SUBJECT: Corrective Action for Pierson Creek Landfill; DuPont-Montague (DuPont);
MID 000 809 640

This letter is in follow up to the January 27, 2015, conference call between the Michigan Department of Environmental Quality (MDEQ), Office of Waste Management and Radiological Protection (OWMRP), DuPont, and DuPont's consultant in which we discussed the MDEQ's review of the May 24, 2014, "Remedial Investigation Report Addendum No. 2 - Pierson Creek Landfill Area" (Report).

DuPont - Pierson Creek Landfill Investigation

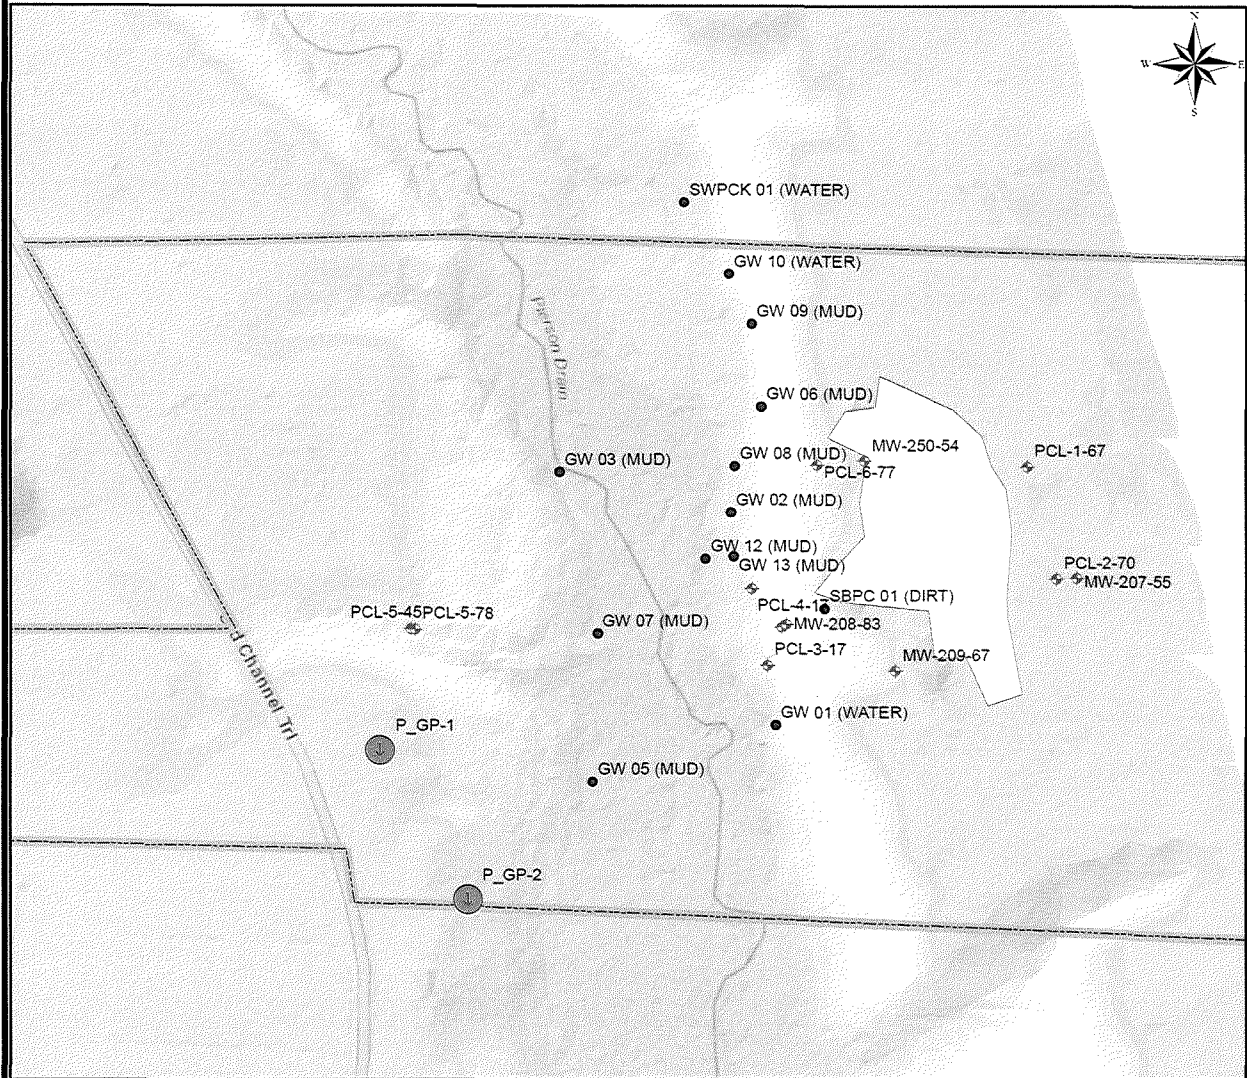
Lacking sufficient geological detail to aid in determining whether all of the impacted groundwater discharges to Pierson Creek, or if a portion of the impacted groundwater underflows the Creek and discharges to Lake Michigan, the regional sink, further investigation is warranted. The first phase of the subsequent investigation is to determine if there is any evidence of the impacted groundwater west of Pierson Creek. Utilizing the PCL-5 series wells and the two boring locations identified on the enclosed map, these locations should provide adequate coverage to demonstrate whether the impacted groundwater extends past Pierson Creek. Use of either of the following two approaches would be acceptable in making this determination:

1. Conduct vertical aquifer sampling from the water table to the base of the aquifer on a five-foot interval. If the analytical results indicate Pierson Creek Landfill constituents, then wells will need to be installed.
2. Install a multiple screened well, with screens at tenfoot intervals. The concept is shown on the second enclosures. If there are detections of Pierson Creek Landfill constituents, the wells will be in place for future monitoring.
